REQUEST FOR ADDITIONAL INFORMATION

Xcel Sports Complex
Pitzner Pkwy
City of Jefferson
Jefferson County

Object Type: Building ICC Regulated Object ID No.: 1543519 Code Applies Date: 06/25/15
Major Occupancy: Assembly; Type IIB Metal Frame Unprotected class of construction; New plan; 50,800 project sq ft;
Occupancy: A-3 Other Assembly Uses; Sprinkler Design: NFPA-13 Sprinkler

⑥A Life Safety Plan
1/32" = 1'-0"

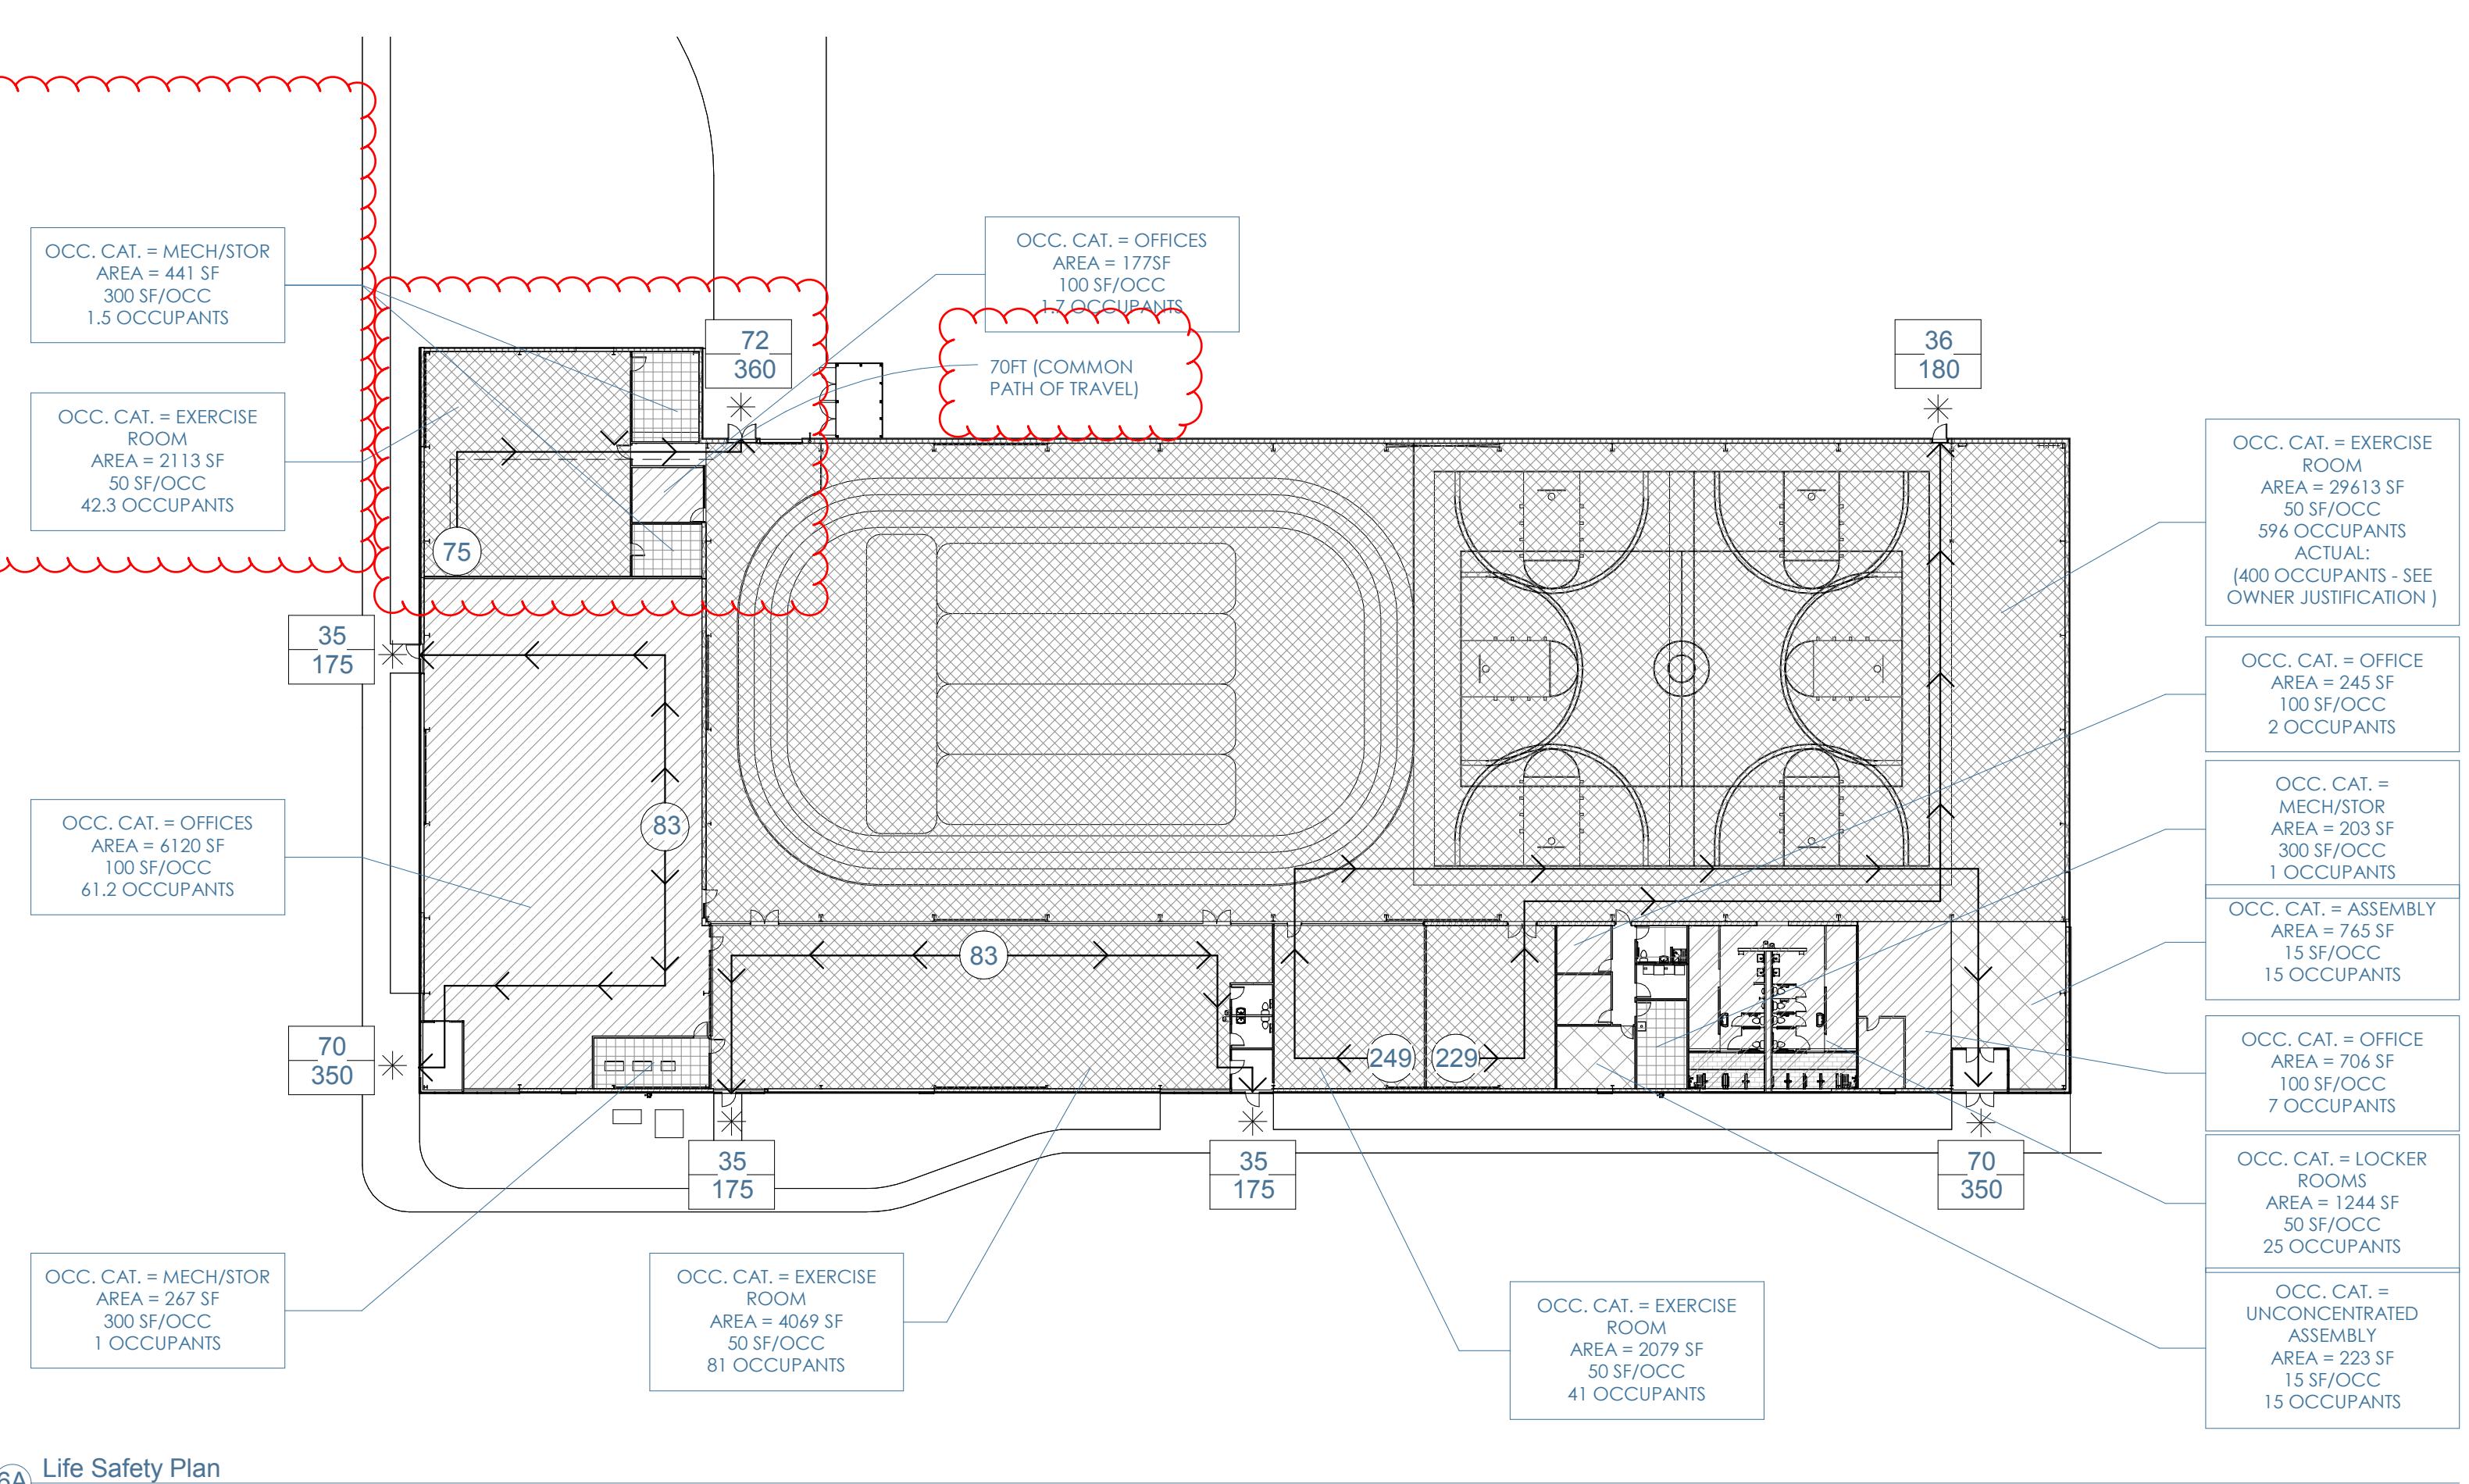
- **IBC 1015.1** - Two exit or exit access doorways from any space are required when the occupant load of the space is greater than the values within Table 1015.1 when the common path of travel is greater than the limitations stated in Section 1014.3, and per other referenced sections. *Refers to Wrestling 122.*
